North – South Commuter Railway (NSCR) Project (Malolos – Tutuban) Package CP01: Elevated Structures, 7 Stations and Depot			
ITEM NO.	REFERENCE CLAUSE/ SECTION	CLARIFICATION REQUEST	RESPONSE
General			
1	GBB No. 6, Annex A, Items 37 & 38, Pages 15 & 16 of 42	<p>The responses in Bid Bulletin No. 6 do not answer the Bidder's clarification request.</p> <p>The Bidder reiterates that the Polyisocyanurate (PIR) insulation is unable to provide a 2-hour fire rating as per TS 500, Clause 513.1 (page TS500-126).</p> <p>The Bidder requests to either:</p> <ul style="list-style-type: none"> a) have the fire rating requirement reduced if PIR is to be maintained <p>or</p> <ul style="list-style-type: none"> b) have the PIR material substituted with Rockwool insulation to maintain the 2-hour fire rating. 	<p>The response in GBB No. 6 clarified the 2-hour fire-rating requirement is not for the Polyisocyanurate insulation alone.</p> <p>The Bidder shall consider the 2-hour fire rating for the PIR roof as a combined system which includes- upper/lower metal skin plus 100mm thick Insulation system. The Bidder shall confirm with prospective local or overseas manufacturer/s whether their PIR roofing system

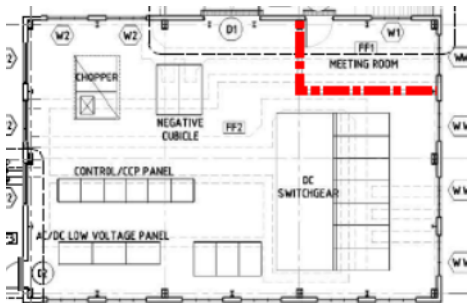
13	Page CP01-B8-520	On CP01-B8-520, please provide the specification and detail of the Expansion Joint (Roof to Roof).	Please refer to TS 500, Page TS500-507. The Contractor shall price the expansion joint based on his supplier's recommendation and details, subject to the Engineer's review and approval.
14	PagesCP01-B8-520 and CP01-B8-531	The existence of Canopy for Shutter, (Grid 16 to 17/A) differs as follows, CP01-B8-520 ··· Non-existent CP01-B8-531 ··· Existent	Yes, the Bidder's assumption is correct. The canopy of shutter door is existent.

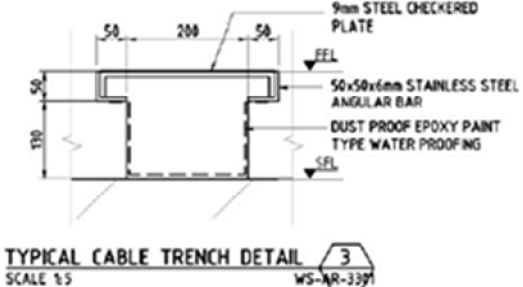
North – South Commuter Railway (NSCR) Project (Malolos – Tutuban) Package CP01: Elevated Structures, 7 Stations and Depot			
ITEM NO.	REFERENCE CLAUSE/ SECTION	CLARIFICATION REQUEST	RESPONSE
		May we assume the one indicated on CP01-B8-531, Existent, to be correct?	
15	Page CP01-B8-524	On CP01-B8-524, may we assume that the Finish of the Waterproof Test to be Polyurethane base membrane waterproofing?	Yes, the Bidder's assumption is correct. Waterproof Test Area shall be Plain Cement with Hardener surface floor finish with Polyurethane base membrane waterproofing.
16	Page CP01-B8-534	CP01-B8-534 shows Workshop pit detail with 150x75x6.5x10 structural framing, but does not indicate the pitch. Shall we assume this to be at every 600mm? Please advise. 	Please refer to item 219 of Annex "A", GBB No. 12.
17	Page CP01-B8-535	On CP01-B8-535, the size of the Canopy Downspout differs as follows,	Yes, the Bidder's assumption is correct. The Canopy Downspout is Ø=75mm SUS pipe.

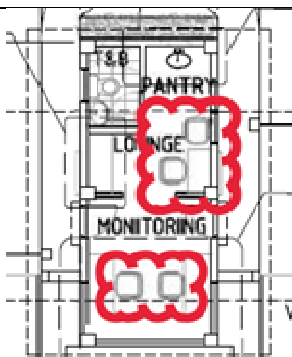
28	Page CP01-B9-127	On CP01-B9-127, Cast Iron Gratings is indicated under Exterior Schedule of Finishes <Others>; please provide the construction range of the Cast Iron Grating.	Please disregard the exterior cast iron grating indicated in the Schedule of Finishes. Please refer to the drawing in Page CP01-B8-003 for new location of Workshop oil storage.									
29	Page CP01-B9-127	On CP01-B9-127, may we assume Louver size for D1 to be W700 x H450?	Please use W600xH300.									
30	Pages CP01-B09-132 and CP01-B09-165	<u>Reference:</u> <i>Wall Finishes</i> Please provide pay item for Plastering for CHB Walls; it is in the schedule of finishes but not in BOQ.	<div>The following item in Page BOQ-229 is deleted:<table><tr><td>D546(5)</td><td>CHB Wall, Non Load Bearing, (Incl. Reinforcing Steel); t=150mm with cement plaster on both sides</td><td>m²</td><td>36.00</td></tr></table></div> <div>Further, the item below in Page BOQ-227 is revised as follows:<table><tr><td>405(8)</td><td>Structural Concrete, Class "AAA" (31 MPa) for Reinforced Concrete Wall (RCW)</td><td>m³</td><td>7.001.00</td></tr></table></div>		D546(5)	CHB Wall, Non Load Bearing, (Incl. Reinforcing Steel); t=150mm with cement plaster on both sides	m²	36.00	405(8)	Structural Concrete, Class "AAA" (31 MPa) for Reinforced Concrete Wall (RCW)	m³	7.00 1.00

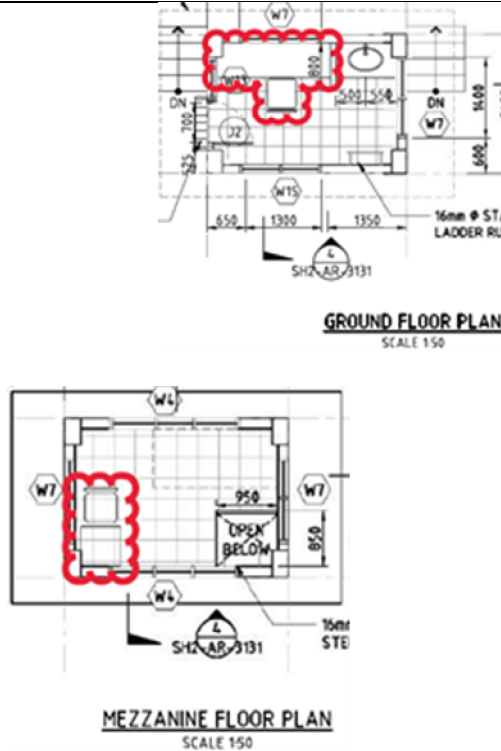
34	Page CP01-B9-271	On CP01-B9-271, may we assume that the detail below to be the detail of Cable Trench (hidden lines) at Floor Plan?	No. Please refer to the notes in the drawing in Page CP01-B9-314.

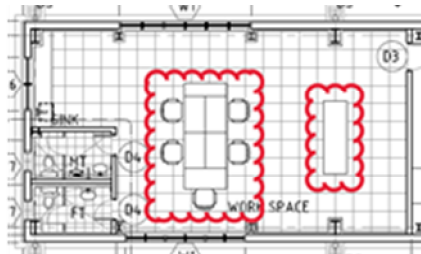
D546(6)	200mm thk CHB wall, plastered on both side	Square meter									
Book 10 of 11											
41	Pages CP01-B10-007 to CP01-B10-009	<p>At Grid 2-3/D, Window call-out differs as follows, CP01-B10-007 ... W1 CP01-B10-008,009 ... W14 May we assume the one indicated on CP01-B10-008,009, W14 to be correct?</p>	Yes, the Bidder's assumption is correct.								
42	Page CP01-B10-009	On CP01-B10-009, may we assume that the specification of the Paint Finish for Exterior wall to be Elastomeric Paint?	Please use Pay Item D547(8), High-performance Urethane Coatings (Masonry Painting) instead of elastomeric paint for the exterior wall of Security House 1 as stated in the drawing in Page CP01-B10-009.								
43	Pages CP01-B10-009 and CP01-B10-011	<p>At Toilet and Bath Ceiling finish differs as follow, CP01-B10-009 ... 12mm Thk Moisture Resistant Gypsum Board in Light Metal Frames</p> <p>CP01-B10-011 ...12mm Thk Gypsum Board Ceiling in Light Metal Frames</p> <p>May we assume the one indicated on CP01-B10-009, 12mm Thk MoistureResistant Gypsum Board in Light</p>	Yes, the Bidder's assumption is correct. The Toilet and Bath Ceiling finish is 12mm Thk Moisture Resistant Gypsum Board in Light Metal Frames.

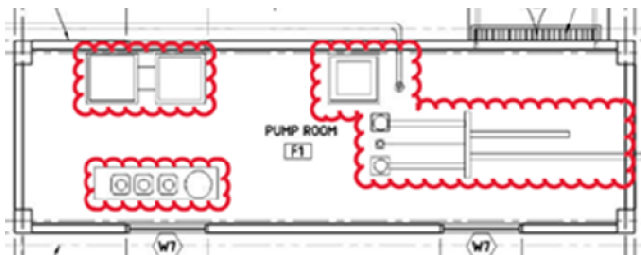
46	Pages CP01-B10-050 to CP01-B10-078 And Volume IA, BOQ, Page BOQ-276	<u>Reference:</u> <u>Flashing</u> Please provide location and details for Pre-painted G.I. Flashing. It has pay item in BOQ and is reflected on the schedule of finishes, but not shown on drawings.	Please consider this as accessories to the Roof and Parapet wall Cladding. Pre-painted G.I. Flashing shall be installed on the back side of steel parapet wall terminating to the roof and gutter.
47	Page CP01-B10-055	On CP01-B10-055, may we assume that the Finish of the Exterior Stairs shown in Ground Floor Plan to be Tamped Concrete Finish?	Yes, the Bidder's assumption is correct.
48	Page CP01-B10-055	On CP01-B10-055, may we assume that the Finish for the Rain Gutter on Grid 2/A-B to be Liquid Type Polyurethane base membrane waterproofing?	Yes, the Bidder's assumption is correct.
49	Page CP01-B10-055	On CP01-B10-055, please provide the specification and detail of the furniture below (marked with a cloud).	Please provide 1 set Pantry Chair – OMP, Mono, as per the drawing in Page CP01-B8-273; 1 set Canteen Table- OMP, Leg, as per Page CP01-B8-273, at Mezzanine Level Please also provide 1 set 550mm X 550mm Mid back Office

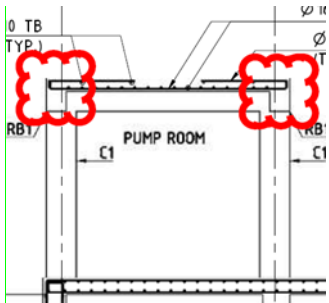
North – South Commuter Railway (NSCR) Project (Malolos – Tutuban) Package CP01: Elevated Structures, 7 Stations and Depot			
ITEM NO.	REFERENCE CLAUSE/ SECTION	CLARIFICATION REQUEST	RESPONSE
		 <p>GROUND FLOOR PLAN SCALE 1:50</p> <p>MEZZANINE FLOOR PLAN SCALE 1:50</p>	<p>Chair with arm rest; Fabric mesh finish at Ground Level.</p> <p>All furniture are to be of high quality and subject for approval by the Engineer. Please refer to TS500, Clause 554 Furnishings.</p>
50	Page CP01-B10-055	On CP01-B10-055 Guard House Room, may we consider the specification of the wall indicated below to be 100mm thk. CHB?	Yes, the Bidder's assumption is correct.
